# HISTORIC LANDMARK COMMISSION

**RONALD McDonald HOUSE  
PLNHLC2011-00503  
901 East South Temple  
December 1, 2011**

The Ronald McDonald House, represented by CRSA Architects, is requesting approval of a Certificate of Appropriateness Involving New Construction of a building with a fifteen (15) foot height exception.

Elevation View from South Temple Street

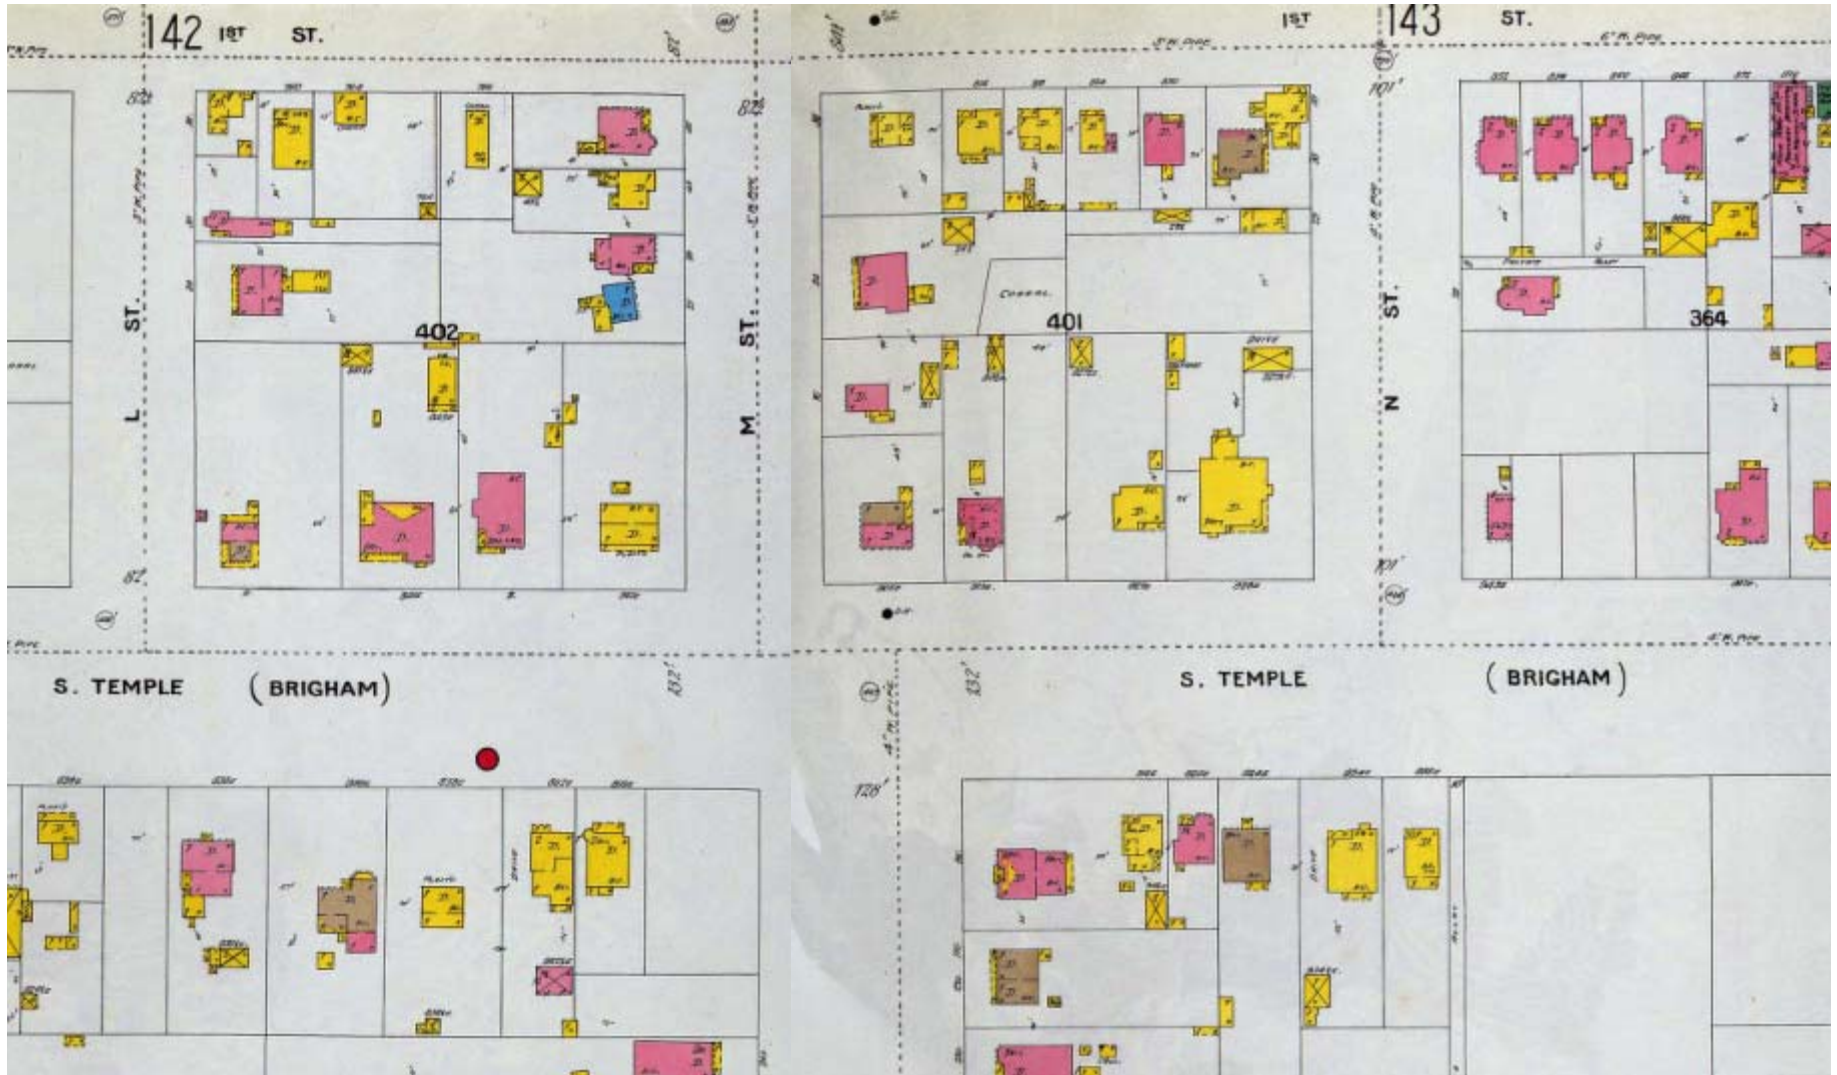
**Analysis:** The applicant has revised the proposed drawings to better suit the direction of the HLC. Revisions include:

1. Removed gables from corner and bay windows.
2. Removed curved sun shades from corner and gabled bay windows.
3. Added flat roof at top of 3<sup>rd</sup> story on corner and at square bay windows.

4. Made two window pairs at curved bay windows and the windows above the curved bays at the 4<sup>th</sup> floor.
5. Added porch and different entry at corner.

6. Made overhangs deeper.
7. Modified 4<sup>th</sup> floor of corner tower so that curve of windows matches curve of bay windows.
8. Changed the brick so that there is a dark base, medium middle and light top.

9. Added recessed brick courses to base brick.
10. Added recessed brick courses at corners of tower and top of tower as well as at square bays to imply quoins at those corners.

11. Changed windows at the corner tower so that the 1<sup>st</sup> and 2<sup>nd</sup> floor have taller transom windows and the 3<sup>rd</sup> floor smaller transom windows.

12. Changed windows on the corner tower 4<sup>th</sup> floor so that there are four instead of three.
13. Changed windows on the rest of the building so that the 1<sup>st</sup> and 2<sup>nd</sup> floors have transoms.

14. Made the headers above doors and windows taller.

In reviewing the proposal, staff has found that the revisions to the building are an improvement, in that the design changes combine to make the building more architecturally compatible with other buildings along South Temple. The new features of the building are similar to those found on other large, significant buildings along the street. Further, it is noted that the changes will reduce the visual impact of the height as viewed from the street. Eliminating the gables and replacing them with flat roofs, using a lighter color brick on the upper floors, increasing the size and weight of the top cornice and the inclusion of lintels over the windows will create a visual effect of capping the height of the building.

On October 20, the Commission emphasized the need for a significant entrance to the building, in this way, the building would “acknowledge” the South Temple frontage. The applicant responded by adding a porch and a different, more visible, entry to the southwest corner. Staff has reviewed the entrance, and finds that in and of itself, the entry does not rise to the level of a monument, but it does work to create a nexus between the building and South Temple, which, when combined with the other changes to the structure, constitute a significant upgrade in the design over the previous version.

Site Plan - Grades and Maximum Building Height

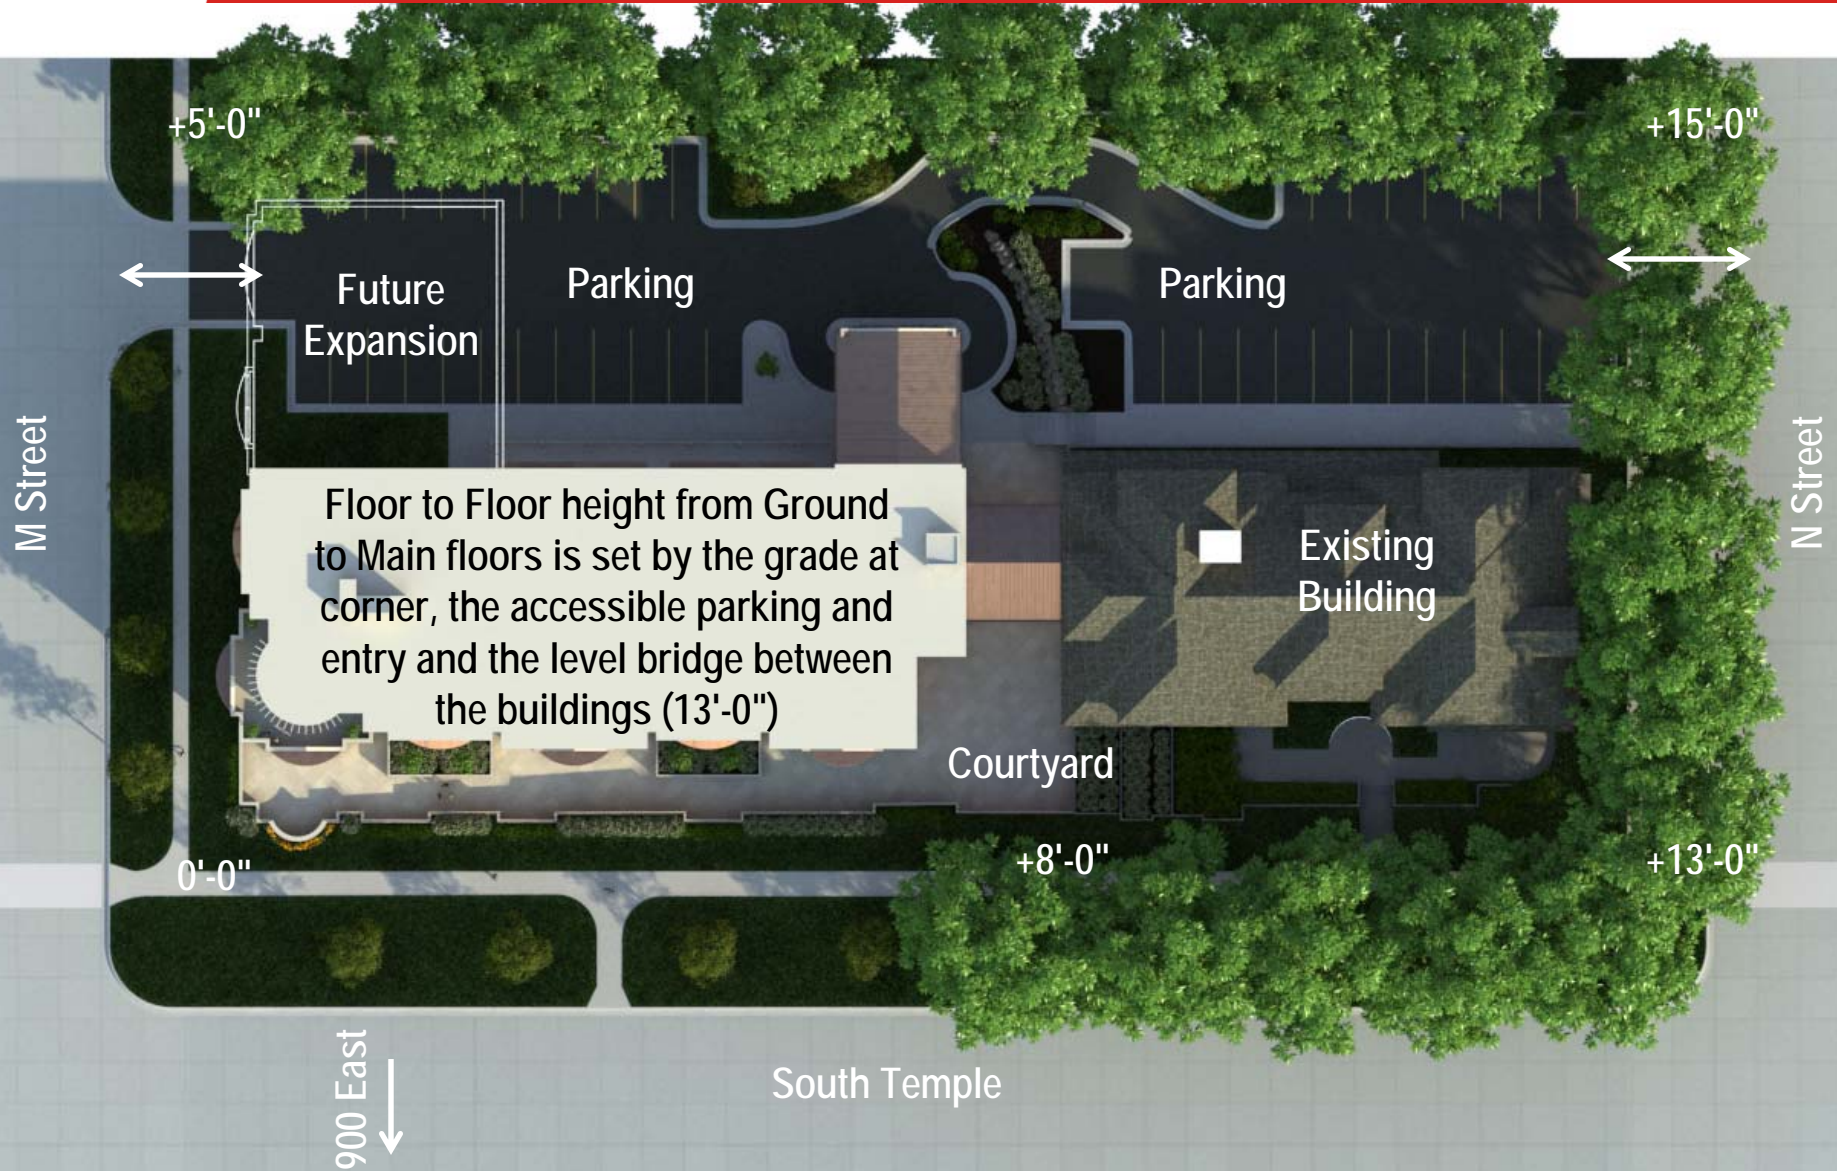
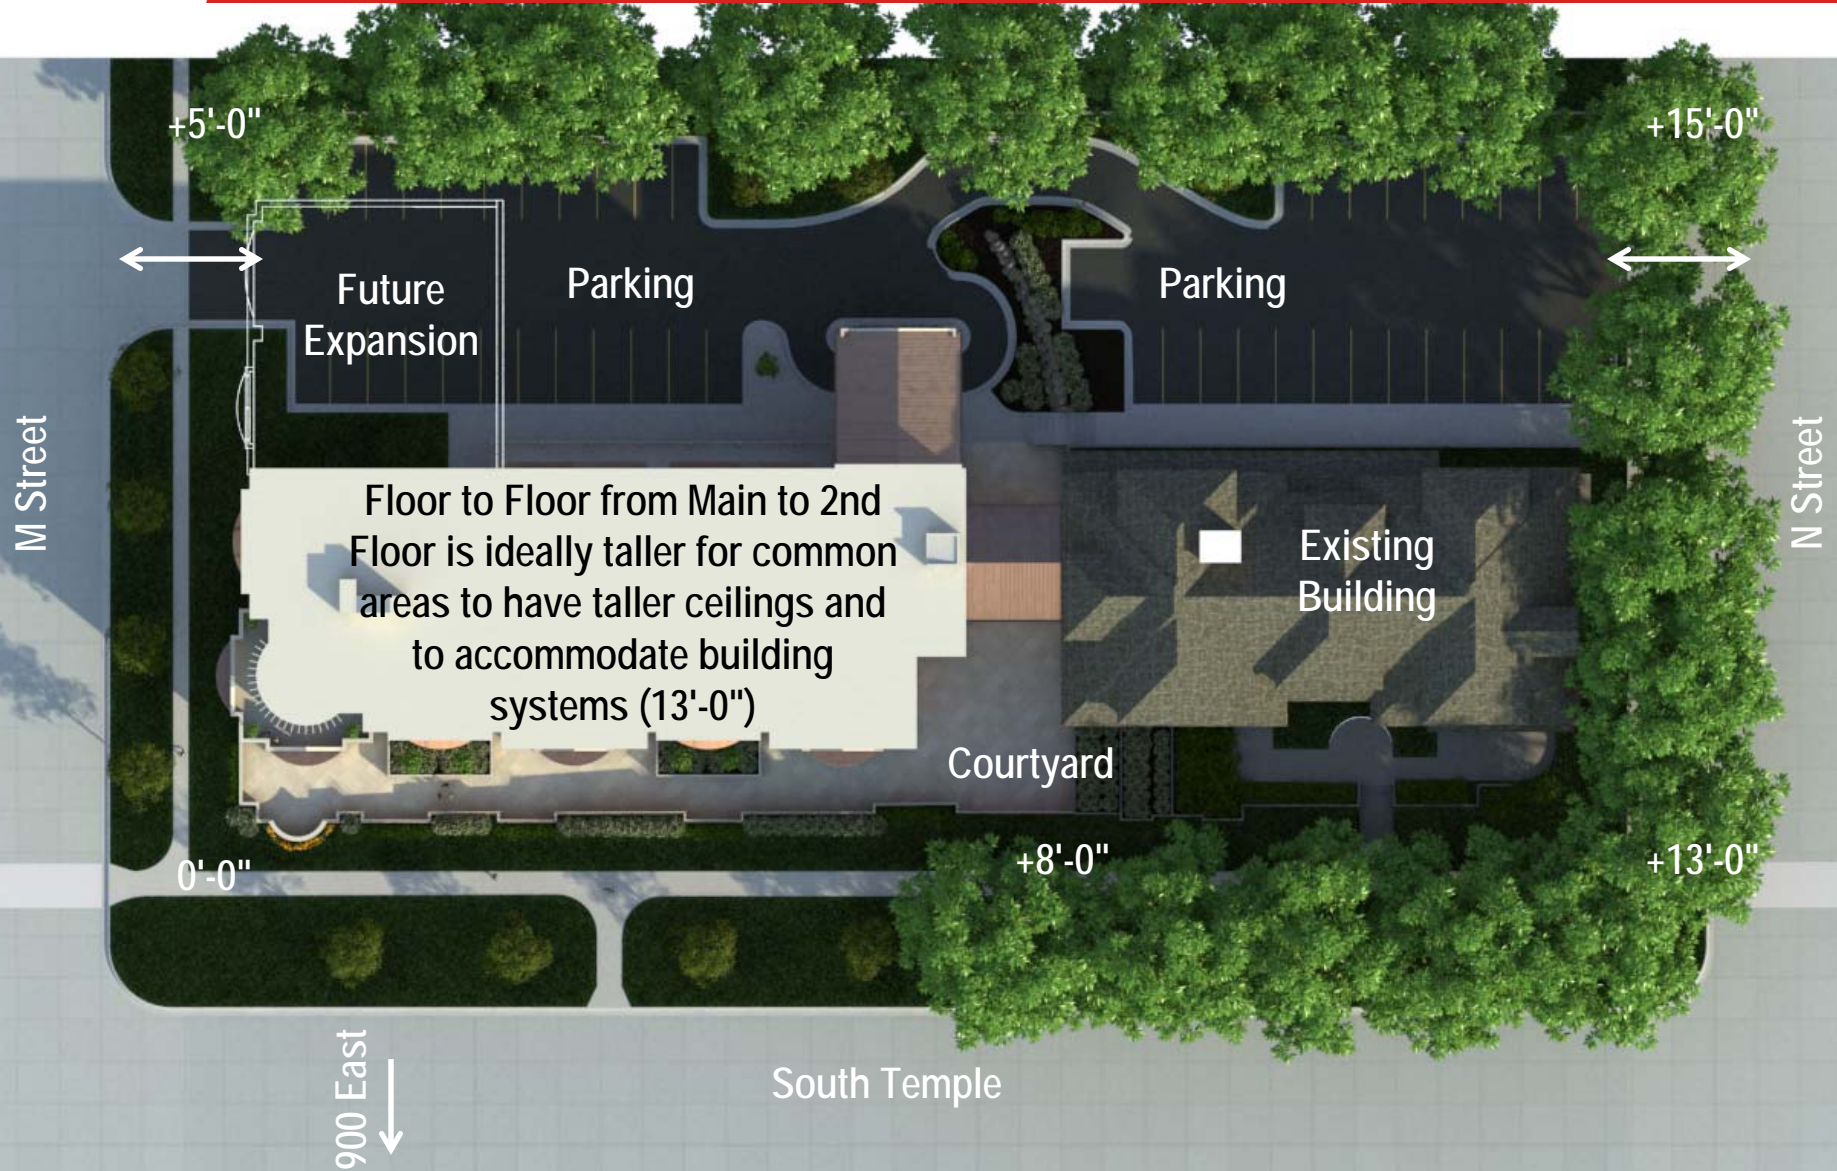
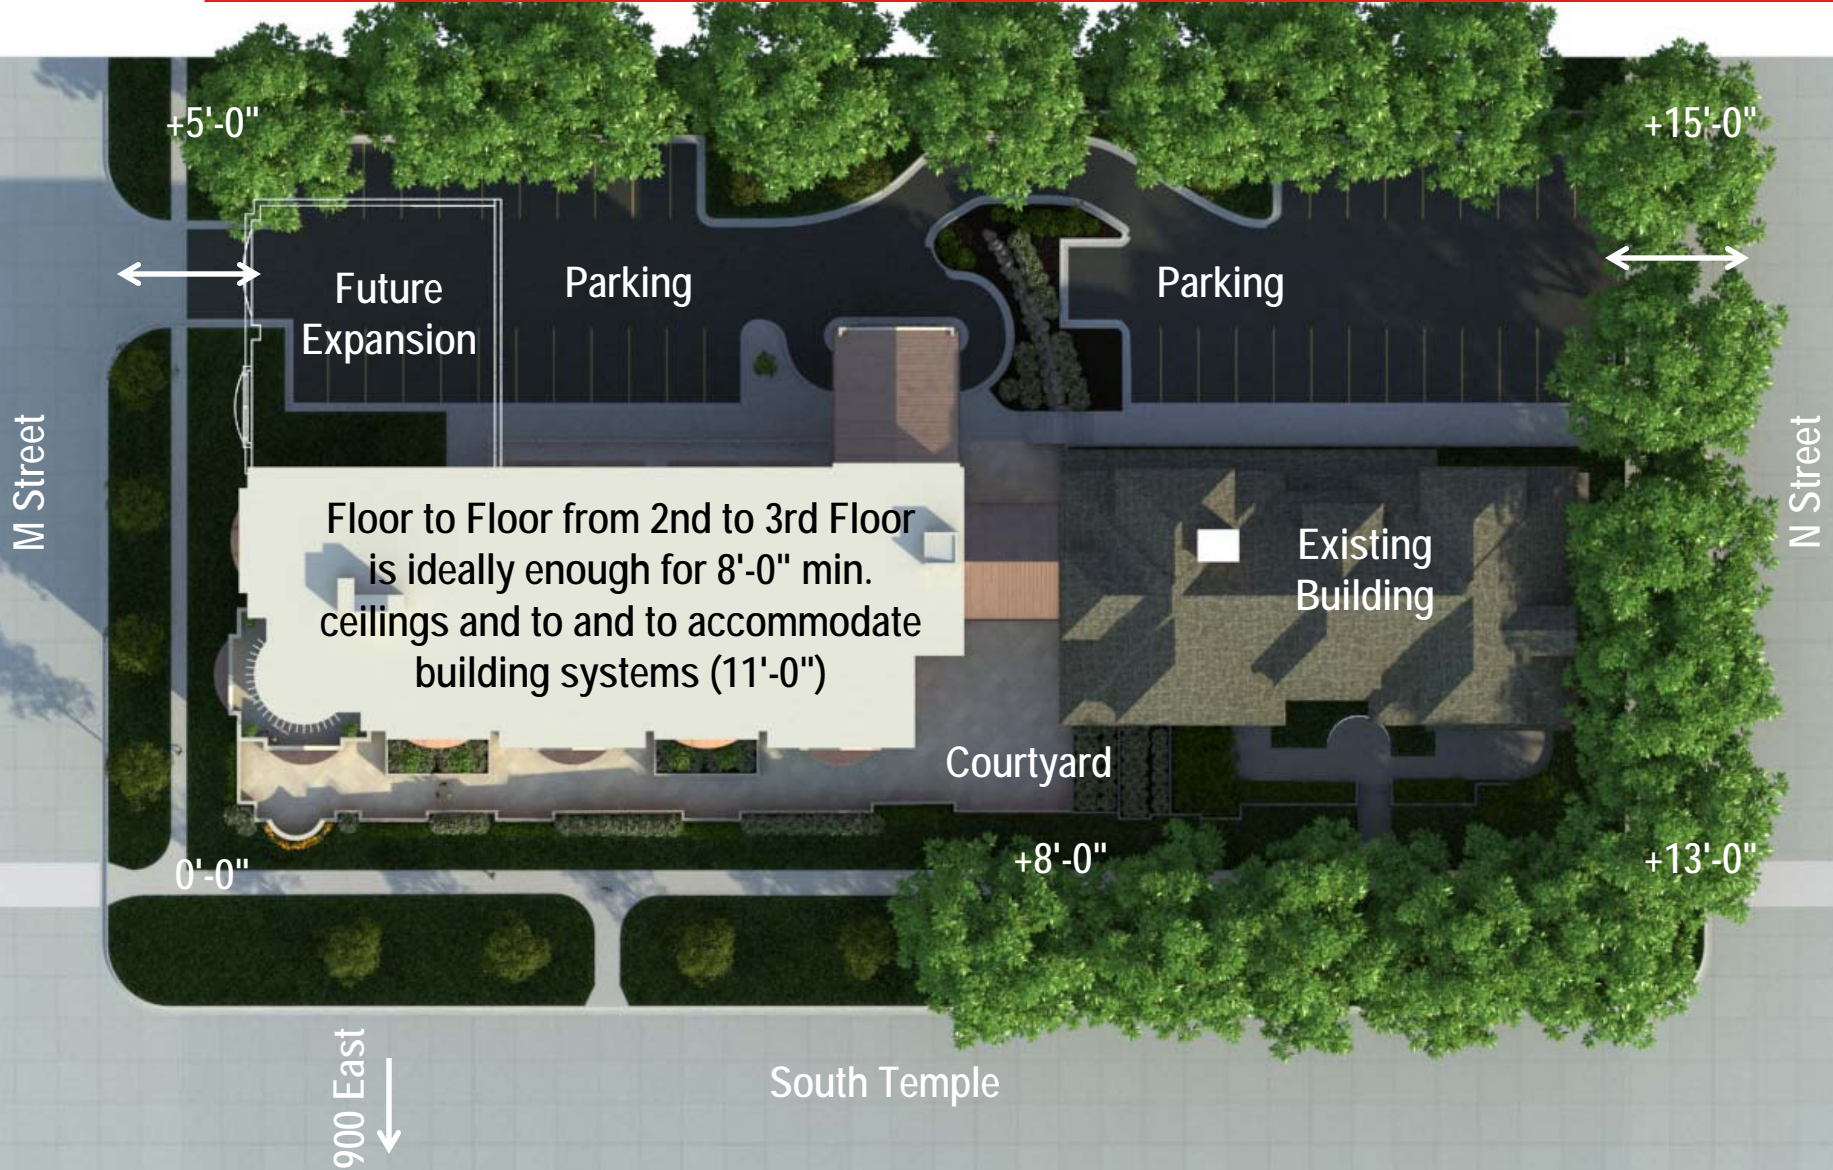
The applicant has petitioned the Historic Landmark Commission for a 15 foot height exception. The maximum height in the RMF-35 zone is 35 feet above established grade. The proposed building would be approximately 50 feet above established grade at its highest point and 43'-6" feet at it's lowest. The applicant's motivation is that the increased height would enable them to meet the future needs of the Ronald McDonald house and manage expected growth.

In order to approve the height exception, the HLC must find that the taller building (50 feet) would be more compatible with the surrounding historic buildings than a building proposed at the allowed zone height (35 feet). The burden of proof lies with the applicant, who must demonstrate that the design of the building meets this standard. At the October 20, work session, the Commission provided the following basis for consideration of a height exception on the site:
